Project Title: Land at Rustington Golf Course, Littlehampton

Project No/ Document Reference: A351 / R008 Rev A

Post Application Response on Highways Matters

Road Safety Audit – Rustington Golf Course

Screenshot of Refuse Vehicle Turning into Site

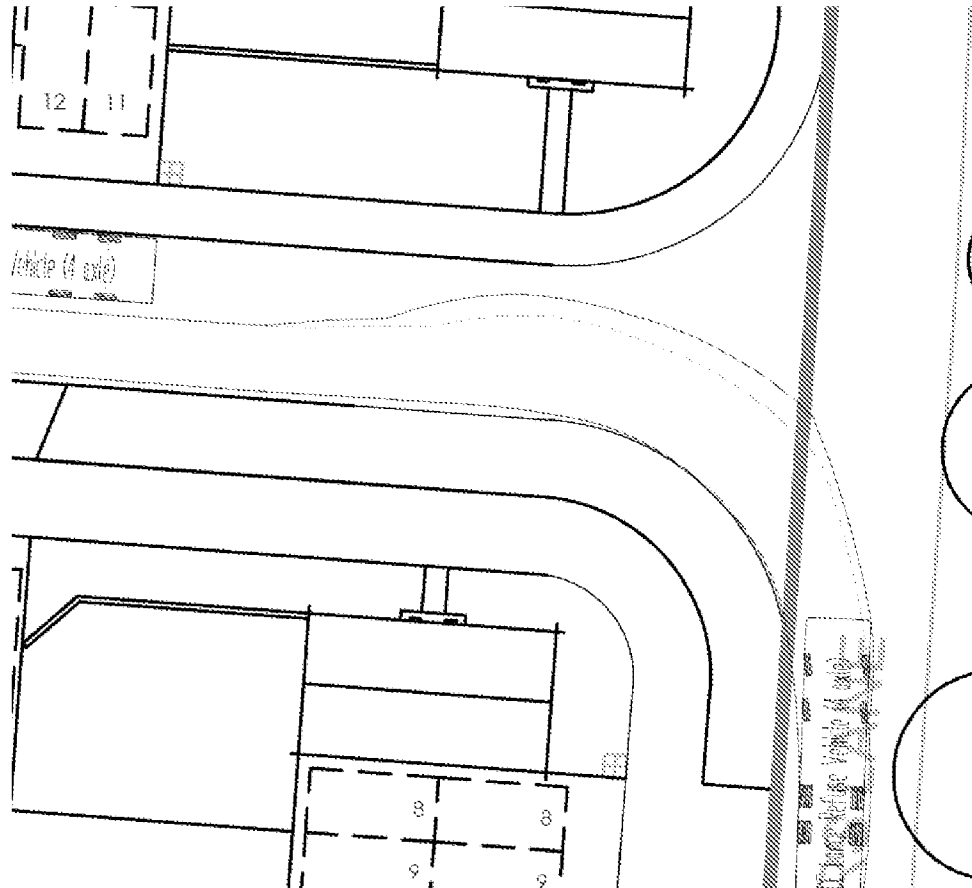
- 2.1. It is noted that WSCC agree that the form and location of the proposed access are acceptable. However, raise a query with regards to the 10m junction radii on the minor arm junction. In this respect Manual for Streets states the following:

- 2.2. The screen shot below shows the turning of an Arun refuse vehicle into the site, it shows that by delivering the access as proposed (with 10m radii), the vehicle can turn safely into the site whilst allowing for some use of the full carriageway at the access. Use of any smaller radii at the junction would result in some overhang of the vehicle onto the footway on the opposite side of the road where residents to the north are likely to be crossing. Therefore, the arrangement proposed delivers safety for all users without allowing the refuse vehicle requirements to dominate the site.

Appendix B: Key Plan showing Audit Problems

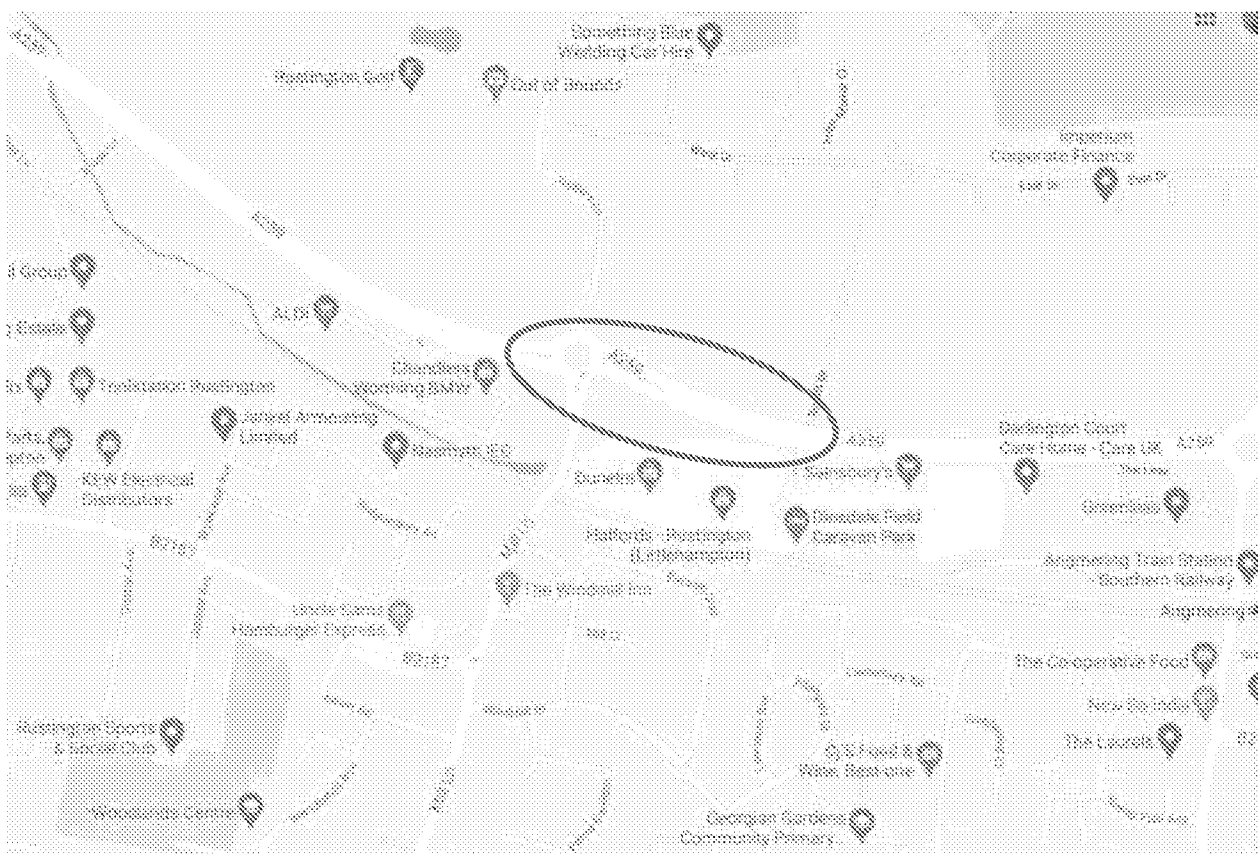
2.1 Problem

Location – Proposed toucan crossing

Summary – Risk of collisions with pedestrians and vehicles and nose to tail type collisions due to visibility

It is observed that vehicle speeds are high and commensurate with the 60/50 mile per hour speed limit. Driver behaviour particularly from the eastbound approach just east of Mill Lane roundabout is observed to speed up after negotiating the roundabout prior to the national speed limit signage. The auditors are concerned that the visibility demonstrated is not sufficient for this direction in particular, and this could lead to late braking endangering pedestrians crossing on a green man or to cause nose to tail collisions with drivers behind unaware of the presence of the crossing and lights changing. In the other direction, the visibility is better, but overhanging branches from the golf course could interfere with this sight line. No speed data has been provided to check if the visibility is appropriate or pedestrian or cycle count information has been provided.

Recommendation – Firstly undertake speed counts to ascertain visibility required from both directions. To improve visibility move the crossing further away westwards from the roundabout, before the retail park entrance. Cut back overhanging branches from the eastbound direction adjacent to the golf course. Reduce the speed limit on approach to the crossing from the west so that the national speed limit starts after the crossing and on the exit of the entrance to the retail park. Install permanent signage to warn of the presence of the crossing. Install double height signals as per the existing signalised crossing east of the Mill Lane roundabout. Install high friction surfacing to reduce the likelihood of late braking causing rear end shunts.

2.2 Problem

Location – Proposed crossing west of roundabout

Summary – Risk of cyclists falling from shared use path

The existing situation is that there is a gap within the vehicle restraint barrier adjacent to the Manor Retail Park with a steep bank below. The provision of the toucan crossing for the eastbound direction will cater for cyclists and pedestrians making a perpendicular movement for the first time. Cyclists particularly crossing at this location will have to turn left or right when reaching the pavement from the north and there is the risk that cyclists will become unstable during the manoeuvre and fall through the missing restraint, down the bank, injuring themselves.

Recommendation – Extend the vehicle restraint barrier either side from Mill Lane to the retail park, bearing in mind the steps, or provide cycle appropriate railings instead.

2.1	Proposed Toucan Crossing	Risk of Collisions due to visibility	Undertaken speed surveys to ascertain visibility required. Reduce speed limit on approach to crossing. Install warning signs, high friction surfacing and double height signals.	Speed surveys have been undertaken with 85 th percentile speeds of between 49-55mph on the eastbound approach and 33mph on the westbound approach. The visibility splays therefore shown on the drawing from approaches to the junction are commensurate to the observed speeds. Notwithstanding, the developer is willing to support measures such as an extension of the 50mph zone (the observed speeds would support this), as well as double height signals and high friction surfacing on the approach both to reduce vehicle speeds and increase the conspicuous nature of the junction.

2.2	Proposed crossing west of roundabout	Risk of cyclists falling from shared use path	Extend the vehicle restraint barrier either side from Mill Lane to the retail park.	Agreed, the land in question to deliver such works is located within highway land and as such can accommodate such recommendations which can be picked up at detailed design stage as part of the S278 process.
